Subject: Oconee Nuclear Station  
Docket Nos. 50-269, -270, -287  
Adequacy of Station Electric Distribution Systems Voltages

ADEQUACY OF STATION ELECTRIC DISTRIBUTION SYSTEM VOLTAGE

OCONEE NUCLEAR STATION

RESPONSES TO ENCLOSURE OF JOHN F. STOLTZ LETTER TO W. O. PARKER

**FIGURE 1**  
 DUKE POWER CO  
 DUCHE MULLER STATION  
 UNIT 3  
 TYPICAL UNIT ELECTRICAL

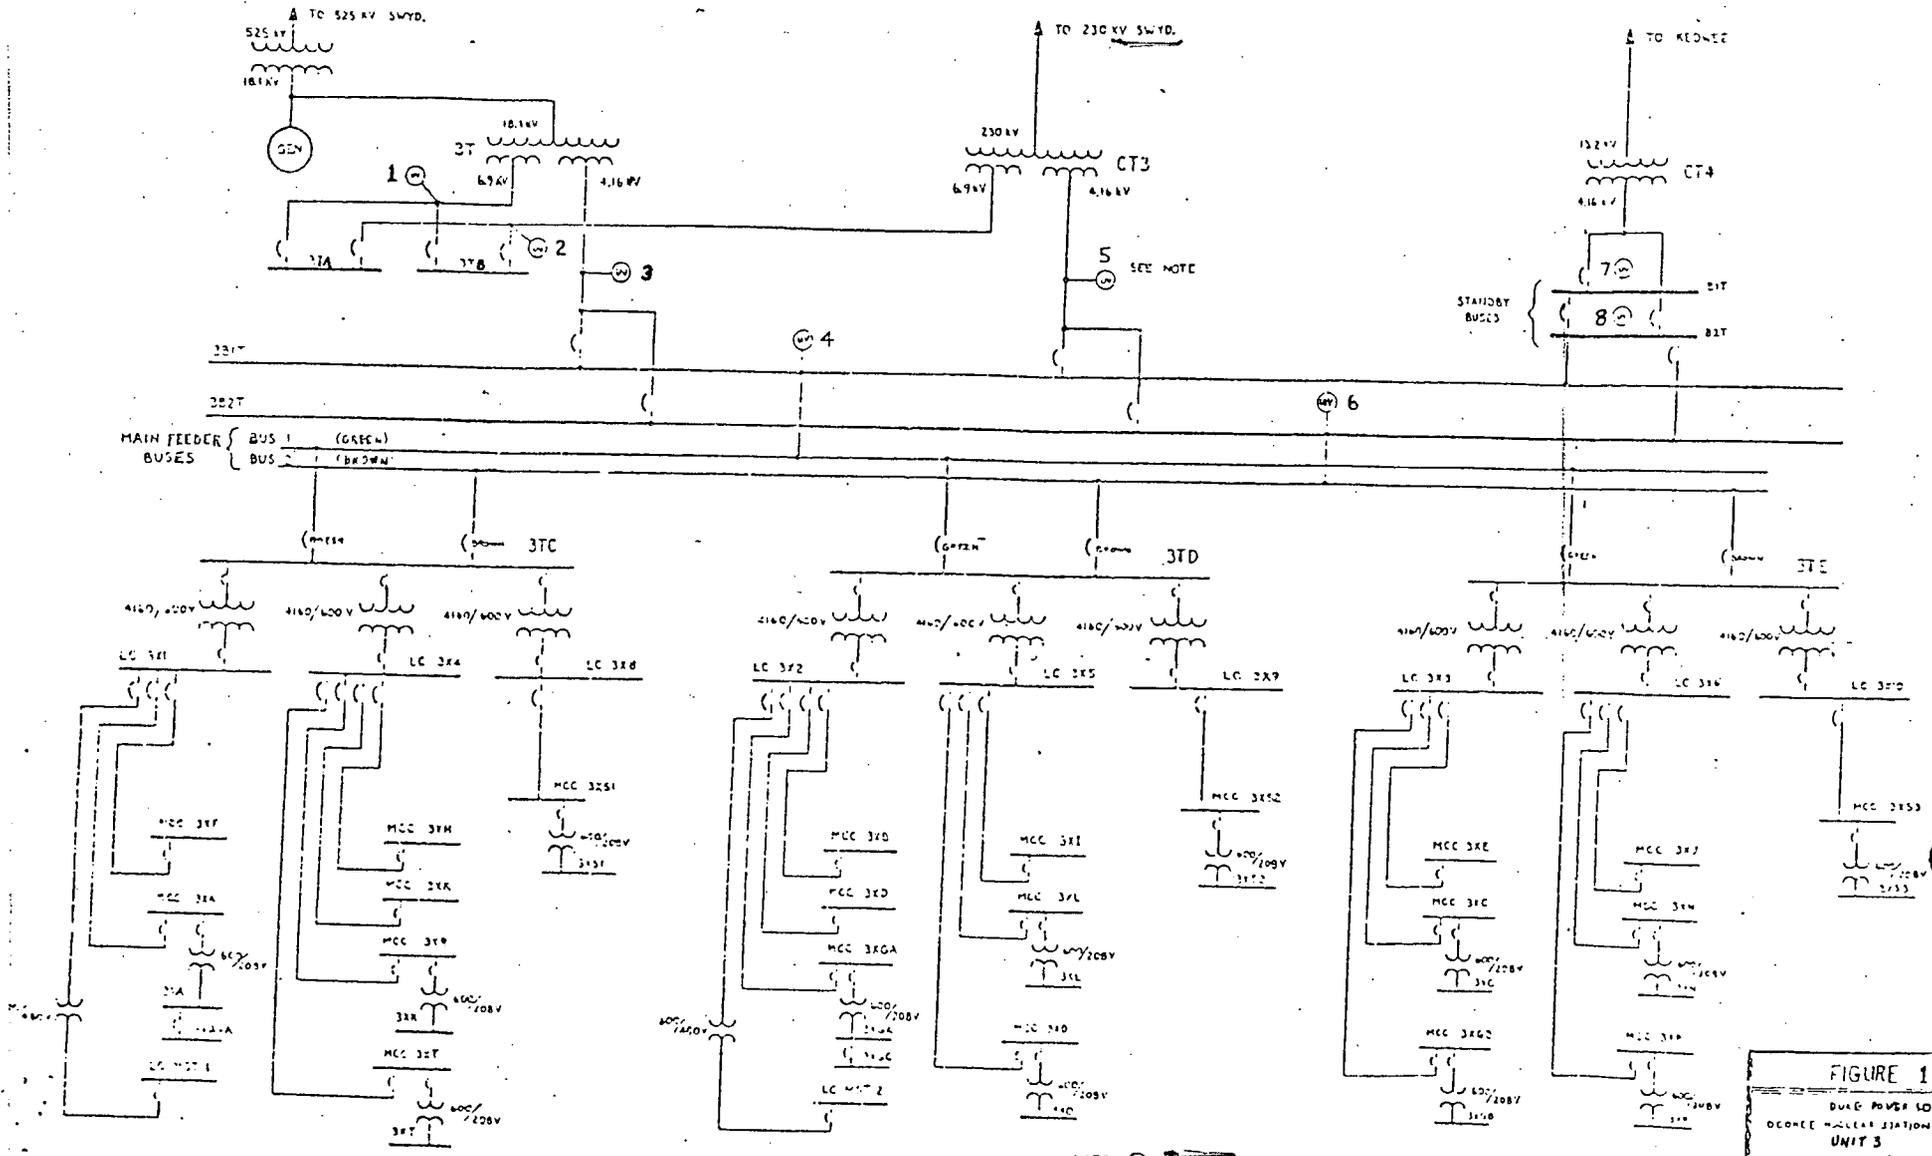
Describe the loss-of-voltage and degraded voltage relaying, including location of relays, coincidence logic and search scheme. Provide a graph that shows two plots (relay characteristics (including tolerances) and the worst case analyzed voltage transient). This should show that there is no possibility of spuriously tripping the offsite source due to minimum analyzed conditions.

Oconee has two undervoltage relaying systems (Figure 1) which will separate the auxiliaries from an unacceptable offsite supply. These systems are the Emergency

Oconee has undervoltage relaying associated with the Emergency Power Switching Logic at four functional locations on the 4.16KV system (See Figure 1, locations 3, 4 & 6, 5, 7 & 8). In all cases, two out of three relay logic is used. The function of the relays are described below:

1. Unit Auxiliary Transformer Undervoltage Relaying (Location 3)

2. Startup Transformer Undervoltage Relaying (Location 5)

3. Main Feeder Bus Monitor Undervoltage Relaying (Locations 4 & 6)

#### 4. Standby Bus Undervoltage Relays (location 7 & 8)
